RD300(A)

CITY OF EUGENE STANDARD DRAWING AMENDMENT

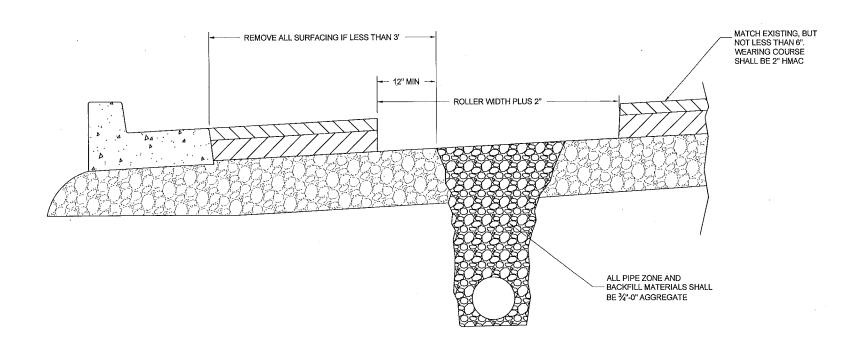
MODIFICATIONS TO RD300 1. DELETE CLASS "C" BACKFILL.
2. "D" DIMENSION SHALL BE 12" IN ALL PIPE SIZES. 3. MINIMUM DEPTH OF TOP SOIL SHALL BE 8". 4. CLASS "B" BACKFILL MAY BE 1-1/2"-0.
5. DELETE GENERAL NOTE 1. AC STREET CUTS SHALL COMPLY WITH CRD302. PCC STREET CUTS SHALL COMPLY WITH DET1601.
·
ADDITIONAL NOTES TO RD300
CITY OF EUGENE
STANDARD DRAWING AMENDMENT Eugene
TRENCH BACKFILL, BEDDING, PIPE ZONE AND MULTIPLE INSTALLATIONS
REVISIONS DATE DESCRIPTION
DATE DESCRIPTION 5/06 DELETE NOTE
1/13 MODIFIED NOTES

RD310(A)

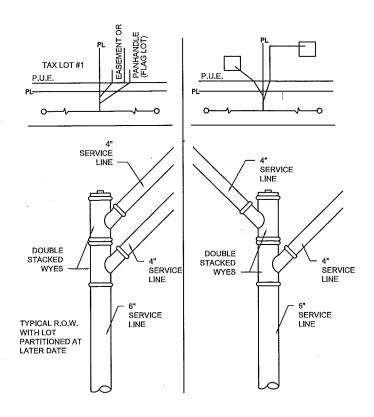
MODIFICATIONS TO RD310

- 1. DELETE RIGHT HAND DETAIL ON DEEP SERVICE.
- 2. DELETE NOTE #4 ON DEEP TRENCH SERVICE DETAIL.
 3. DELETE NOTE #3 ON SHALLOW TRENCH SERVICE.

- (DEEP TRENCH SERVICE): DEEP TRENCH SERVICE
 TO BE USED ONLY WHEN MAINLINE IS GREATER
 THAN 10' DEEP.
- 2. MARKER POSTS AND BLOCKING SHALL BE 2X4, EXTENDING 12" ABOVE SURROUNDING SURFACE AND PAINTED GREEN.

RD317(A)

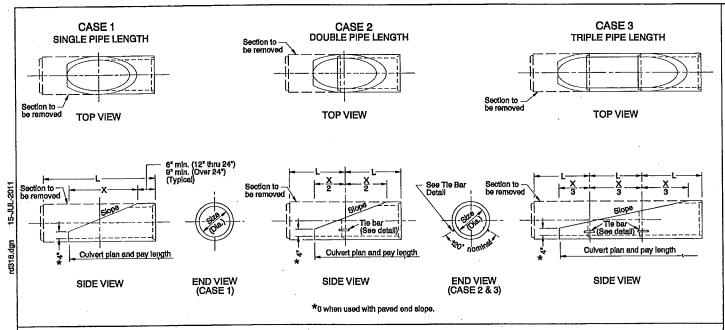
MODIFICATIONS TO RD317

1. OPEN WATERWAY OUTLET PROTECTION TREATMENT SHALL BE USED UNLESS ENGINEER DIRECTS OTHERWISE

RD336(A)

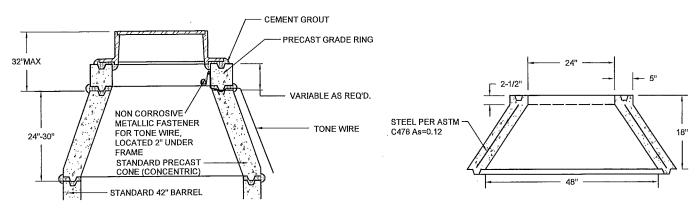
MODIFICATIONS TO RD336

- DELETE ALL REFERENCES TO STEPS. STEPS ARE NOT ALLOWED.
- 2. CONCENTRIC CONES SHALL BE USED UNLESS OTHERWISE SPECIFIED.
- 3. BARREL DIAMETER SHALL BE 42".
- 4. DELETE REFERENCES TO NON-SHRINK GROUT.
- 5. TOTAL PRECAST GRADE RING HEIGHT SHALL BE 12" MINIMUM AND 24" MAXIMUM.
- 6. NON-CORROSIVE FASTENERS FOR TRACER WIRE TERMINATION SHALL BE METALLIC.

- 1. MANHOLES SHALL BE CONCRETE.
- USE 18" HIGH CONE WITH 48" BARREL ONLY WHEN STANDARD CONE WILL NOT FIT, AND WHEN APPROVED BY THE ENGINEER.

RD346(A)

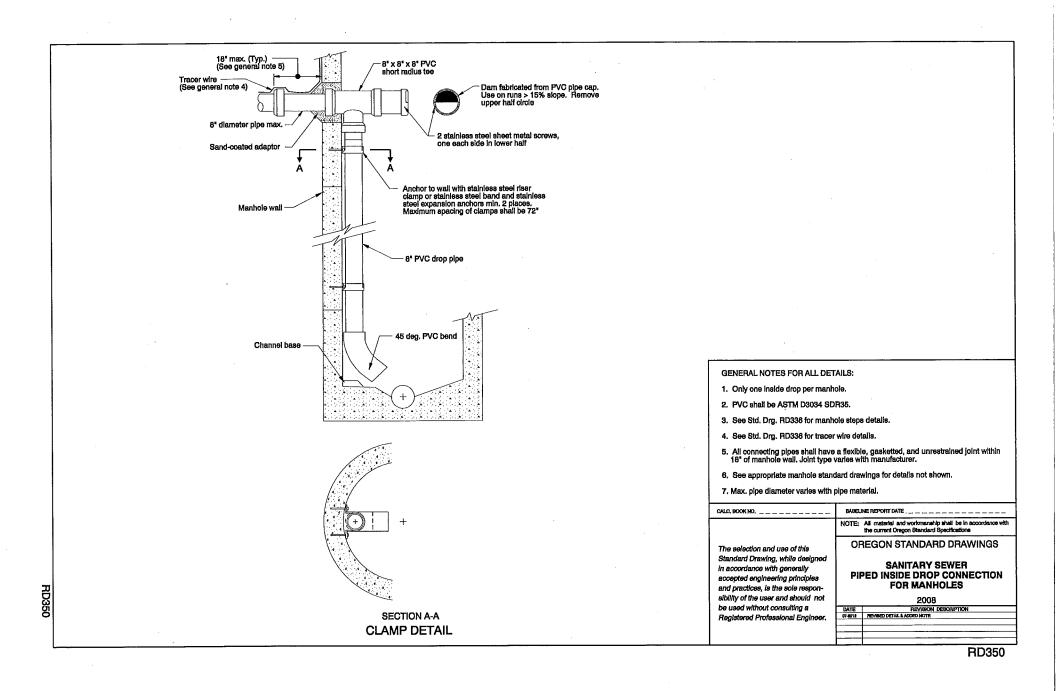
MODIFICATIONS TO RD346

- DELETE ALL REFERENCES TO STEPS. STEPS ARE NOT ALLOWED.
- NOT ALLOWED.
 2. CONCENTRIC CONES SHALL BE USED UNLESS OTHERWISE SPECIFIED.

RD362(A)

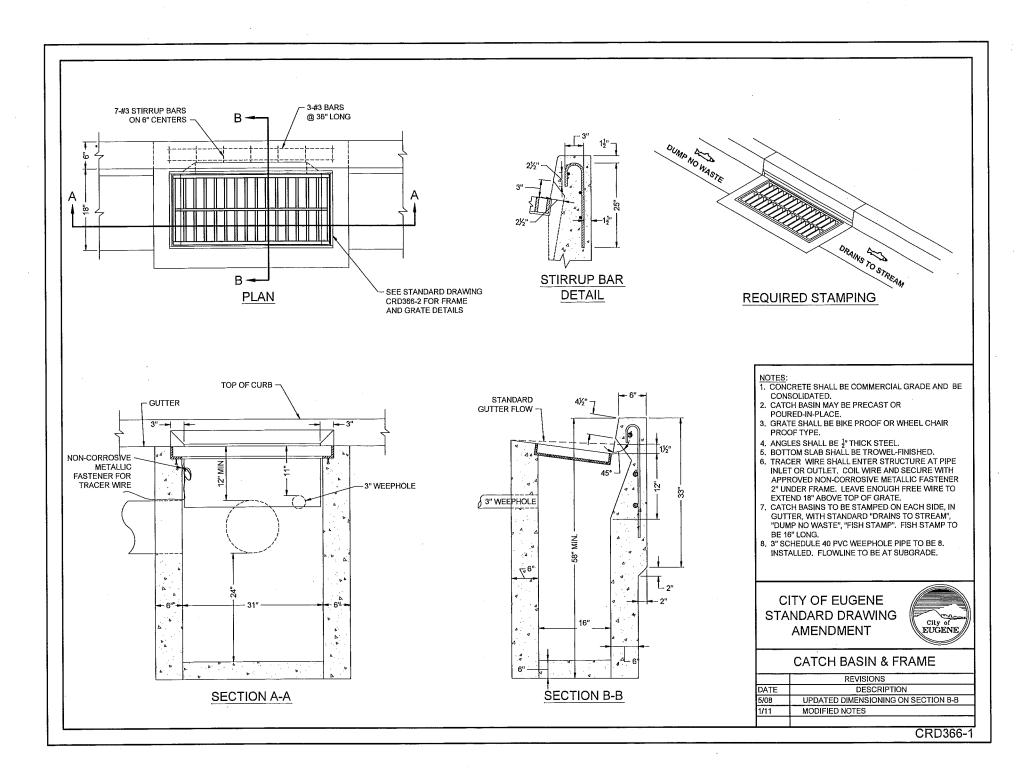
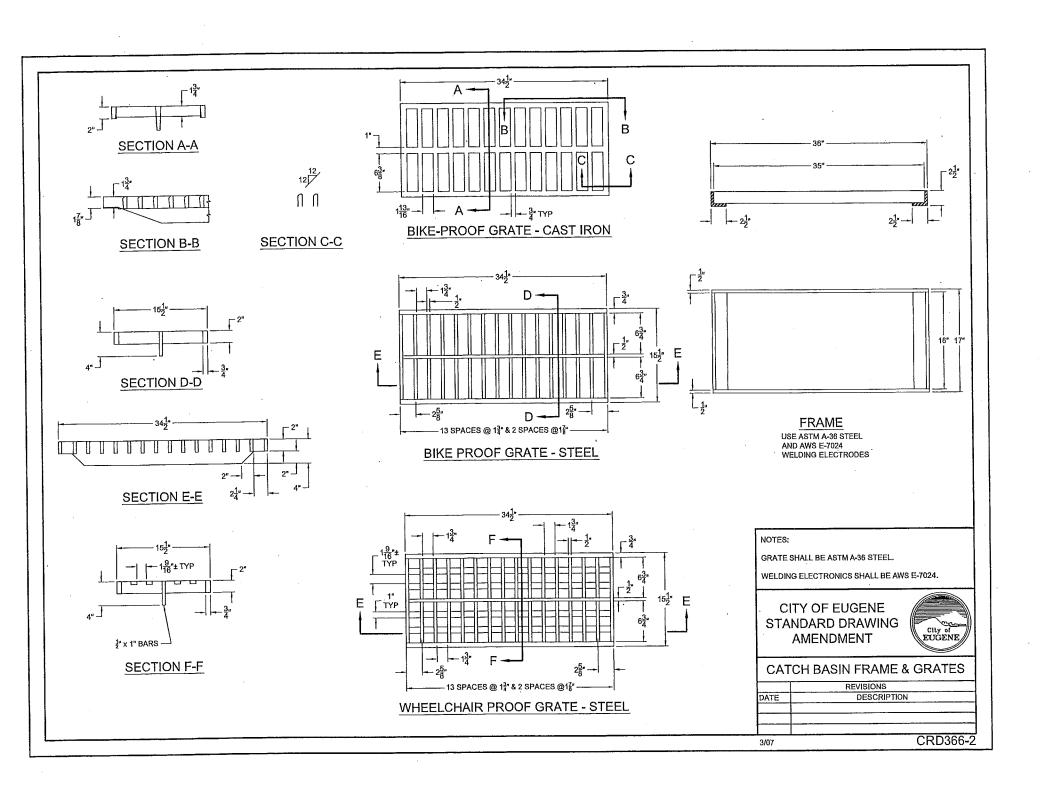
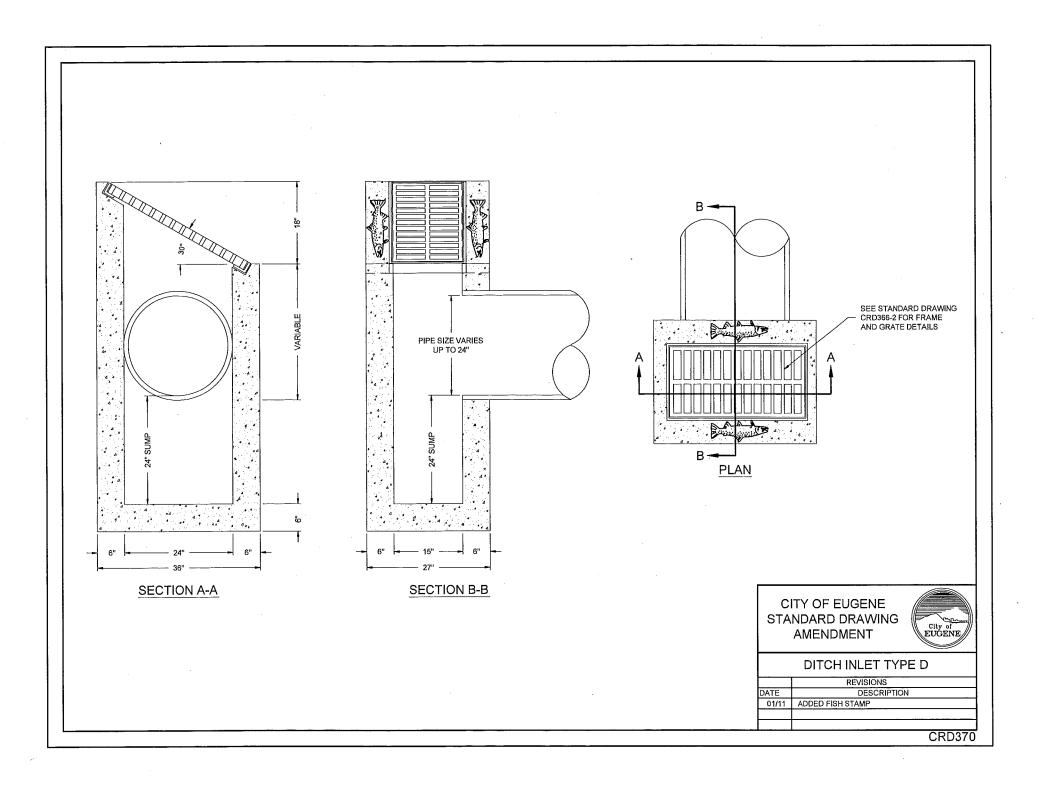
MODIFICATIONS TO RD362

1. CLEAN OUT RISER TO BE 8" MAX.

- IF LOCATED IN SIDEWALK OR OFF-STREET BIKE/PED PATH, LID TO BE COATED WITH TEXTURED NON-SKID SURFACING. 29-E-EPOXY, DECK AND FLOOR TEXTURED COATING, FIRM FOOT, OR APPROVED EQUAL. COLOR TO BE CONCRETE GRAY.
- 2. IF THE CLEAN OUT IS LOCATED IN A NON-PAVED AREA, PROVIDE A 26"X26"X6" SQUARE COMMERCIAL GRADE CONCRETE PAD, OR 26" DIAMETER X 6" DEEP CIRCULAR PAD, AROUND IT.

RD720(A)

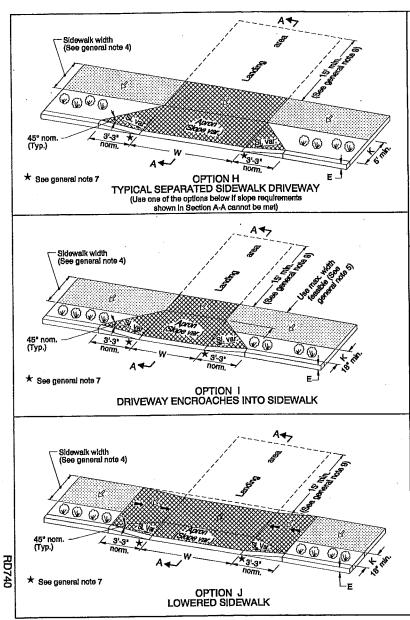
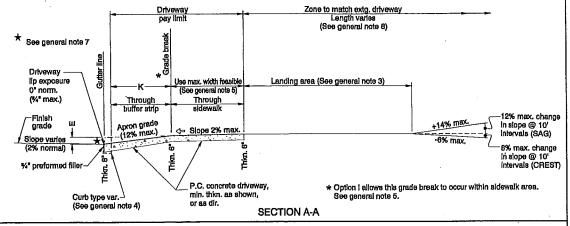
MODIFICATIONS TO RD720

- 1. DELETE GENERAL NOTE 2.
- 2. CONTRACTION JOINTS AND TOOLED "DUMMY" JOINTS SHALL BE ONE IN THE SAME, TOOLED TO 1/3 THE SLAB DEPTH, AND THE DISTANCE BETWEEN THEM SHALL BE EQUAL TO THE SIDEWALK WIDTH.
- 3. ALL TOOLED RADIUS SHALL BE 3/8".
- 4. 1" OF 3/4"-0 AGGREGATE SHALL BE PLACED UNDER SIDEWALKS.
- 5. RESIDENTIAL DRIVEWAY SECTIONS SHALL BE 5" CONCRETE ON 1" AGGREGATE.
- 6. COMMERCIAL DRIVEWAY SECTIONS SHALL BE 7" CONCRETE ON 1" AGGREGATE.
- 7. CHANGE TAPER LENGTH FROM 5' TO 10' ON DETAIL "REQUIRED SIDEWALK WIDENING AROUND OBSTRUCTIONS".
- 8. MODIFY NOTE 3 TO READ "INSTALL 3" PVC WEEPHOLE PIPES IN SIDEWALK LOCATIONS AS DIRECTED BY THE ENGINEER. PLACE CONTRACTION JOINT OVER TOP OF PIPE."

RD740(A)

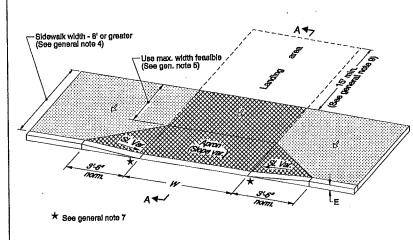
MODIFICATIONS TO RD740

- 1. DELETE SECOND SENTENCE OF NOTE #5.
- 2. DELETE NOTE #6, #8 #10.
- 3. SECTION A-A: DELETE PREFORMED FILLER.
- 4. RESIDENTIAL DRIVEWAY SECTIONS SHALL BE 5" CONCRETE ON 1" AGGREGATE.
- 5. FOR DRIVEWAYS SERVING ALL OTHER USES AND FOR ALLEYS THE DRIVEWAY SECTIONS SHALL BE 7" CONCRETE ON 1" AGGREGATE.

RD745(A)

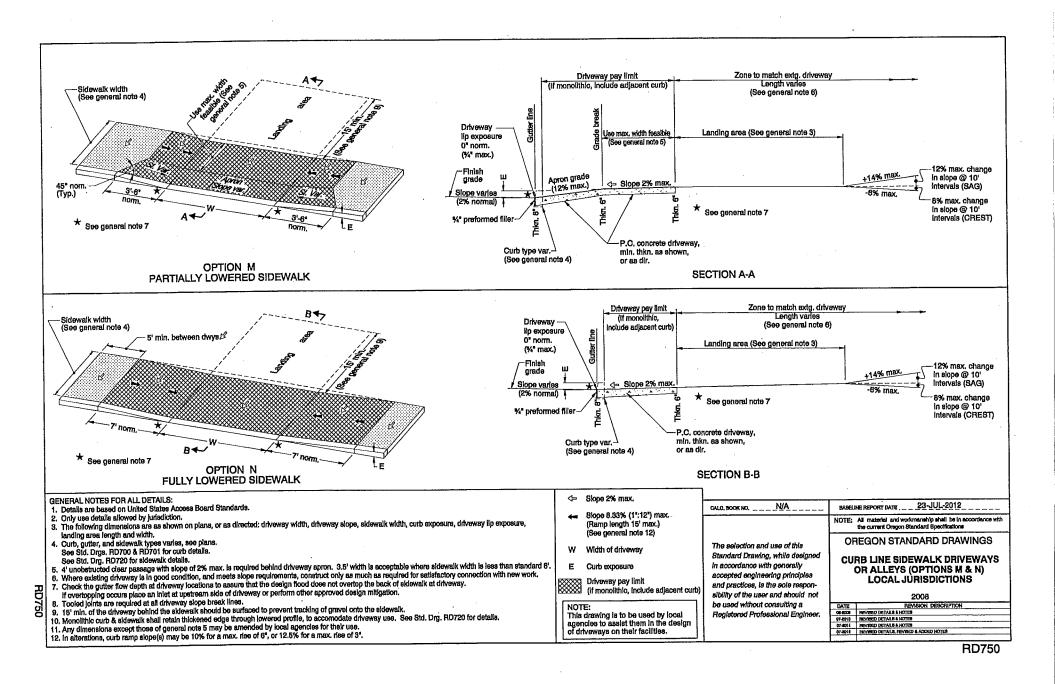
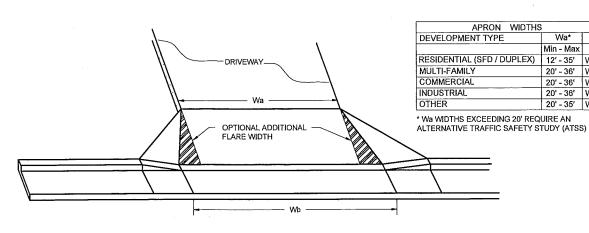
MODIFICATIONS TO RD745

- 1. DELETE SECOND SENTENCE OF NOTE #5.
- 2. DELETE NOTES #6, #8 & #11.

- 3. SECTION A-A: DELETE PREFORMED FILLER.
- 4. RESIDENTIAL DRIVEWAY SECTIONS SHALL BE 5" CONCRETE ON 1" AGGREGATE.
- 5. FOR DRIVEWAYS SERVING ALL OTHER USES AND FOR ALLEYS THE DRIVEWAY SECTIONS SHALL BE 7" CONCRETE ON 1" AGGREGATE.

RD1015(A)

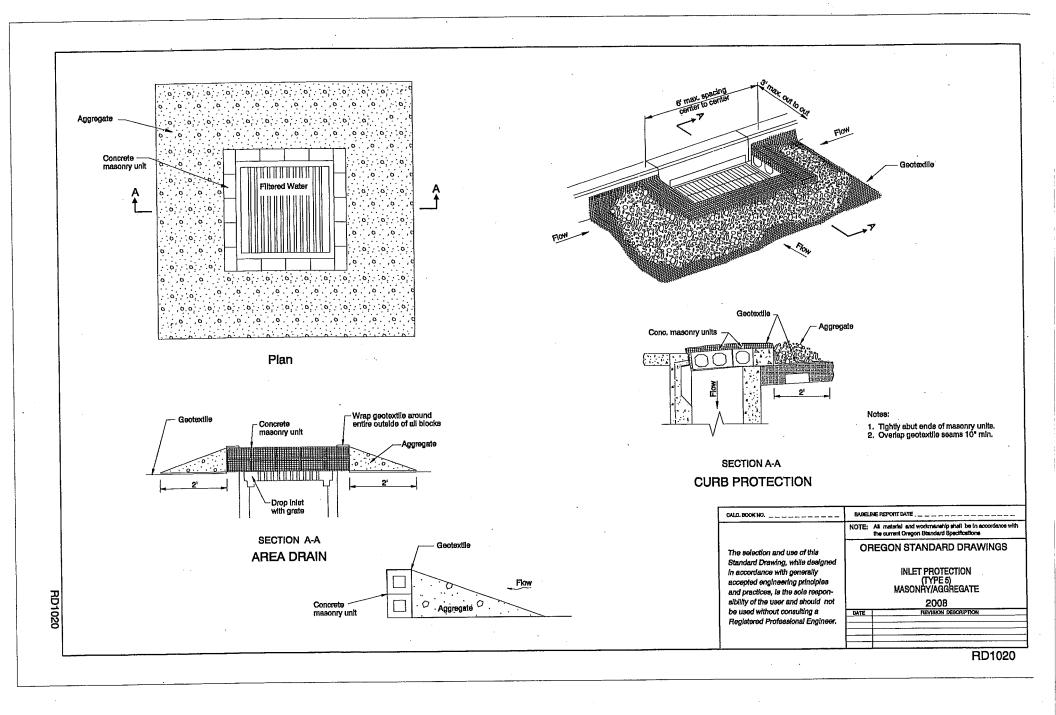
MODIFICATIONS TO RD1015

- CREATE ADDITIONAL BIOFILTER BAG PONDING AREAS AREAS IN INTERVALS AS REQUIRED IN THE GUTTER (5' to 10' TYPICAL).
- MAINTAIN PONDING AREAS. REMOVE SEDIMENT ONCE IT HAS REACHED 1/3 THE HEIGHT OF THE STORAGE AREA.

RD1040(A)

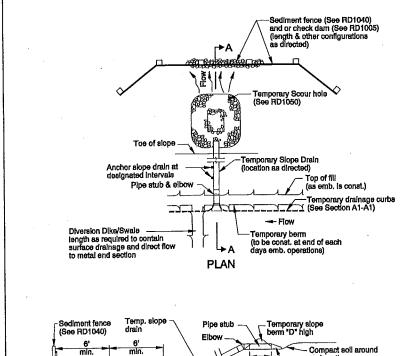
MODIFICATIONS TO RD1040

- SEDIMENT FENCES SHALL BE PLACED ON SLOPE CONTOURS TO MAXIMIZE PONDING EFFICIENCY.
- 2. INSPECT AND REPAIR FENCE AFTER EACH STORM EVENT AND REMOVE SEDIMENT WHEN IT REACHES 1/3 THE EXPOSED HEIGHT OF THE FENCE.
- 3. REMOVED SEDIMENT SHALL BE DEPOSITED TO AN AREA THAT WILL NOT CONTRIBUTE SEDIMENT OFF-SITE AND CAN BE PERMANENTLY STABILIZED.
